## Product / Process Change Notification (PCN)

**PCN #:** PCN\_UtRJ45LAN\_20201209  
**Affected Series:** WE-UtRJ45LAN;7499xxx; S1xxx  
**PCN Date:** September 09, 2020  
**Effective Date:** December 09, 2020

To ensure an improved product assembly, Würth Elektronik will change the form of the insert and material of insert and housing to PA66.

**BEFORE CHANGE**

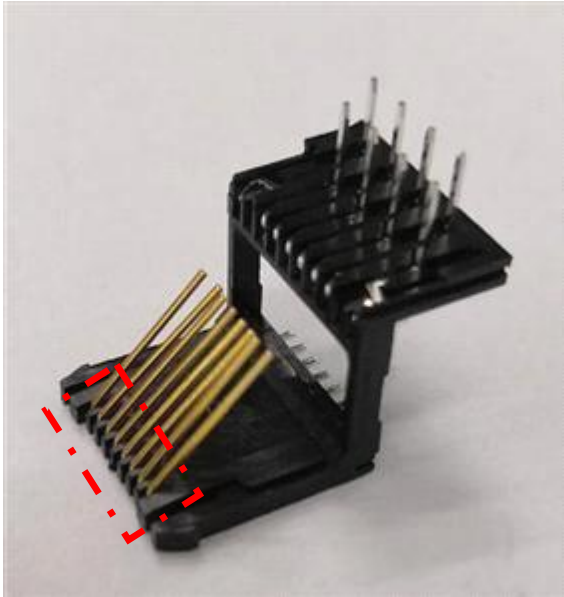
**Straight gold contacts**

Material PA66

**AFTER CHANGE**

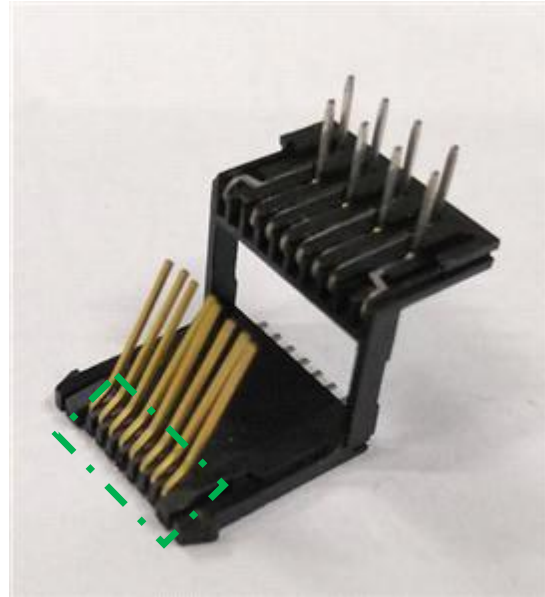
**R-shape gold contacts**

Material: PA66

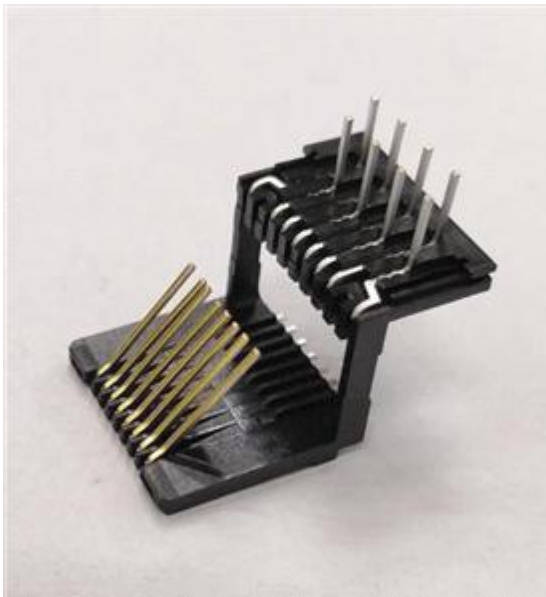
**Material: PBT**

R-shape gold contacts

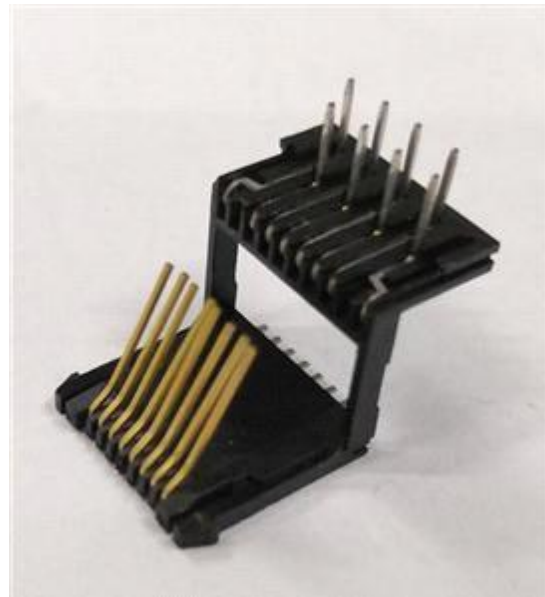
**Material: PA66**

R-shape gold contacts

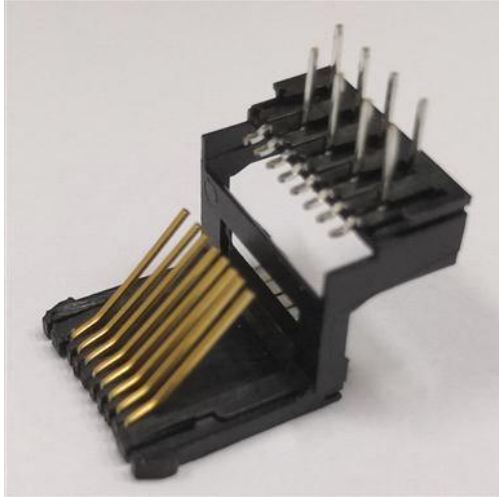
Material: PBT

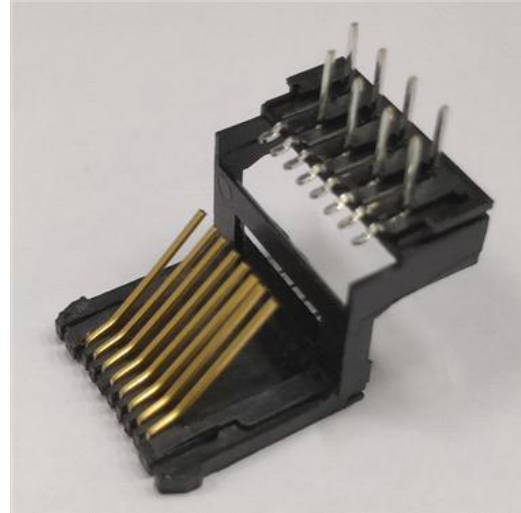
Material: PA66
